Subject: MASTER WARNING LIGHT IS ON AND INSTRUMENT CLUSTER WARNING MESSAGE IS DISPLAYED (DTC P1794 or DTC P1794 and P2502)	Bulletin No: 01-001/14 Last Issued: 05/06/2014
---------------------------------------------------------------------------------------------------------------------------------------------	-----------------------------------------------------------------

- This bulletin supersedes the previous bulletin 01-001/14, issued 02/25/2014, 01/24/2014, 01/10/2014 and 01-028/13, issued on 11/19/2013. The APPLICABLE MODEL(S)/VINS has been revised.
- Changes are noted below in Red beside the change bar.

APPLICABLE MODEL(S)/VINS

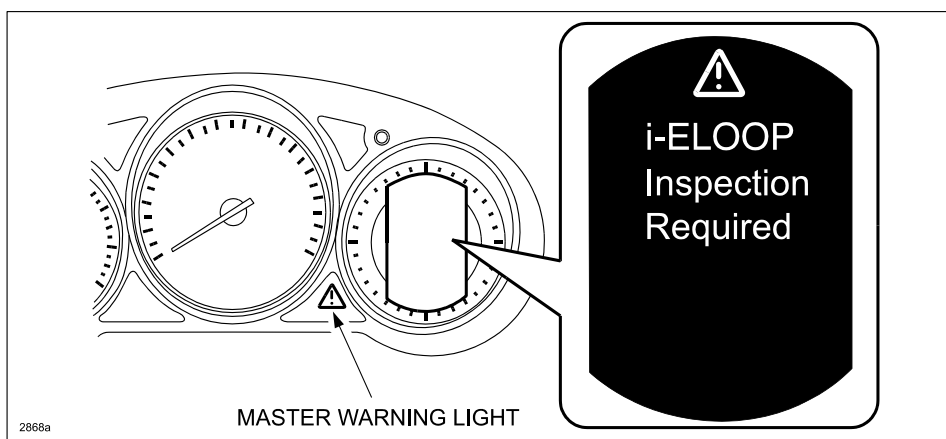
- 2014 Mazda3 vehicles **equipped with i-ELOOP and** with VINs lower than JM1 BM ***** 162663 (produced before December 18, 2013)
- 2014-2015 Mazda6 vehicles **equipped with i-ELOOP and** with VINs lower than JM1 GJ ***** 162912 (produced before December 3, 2013)
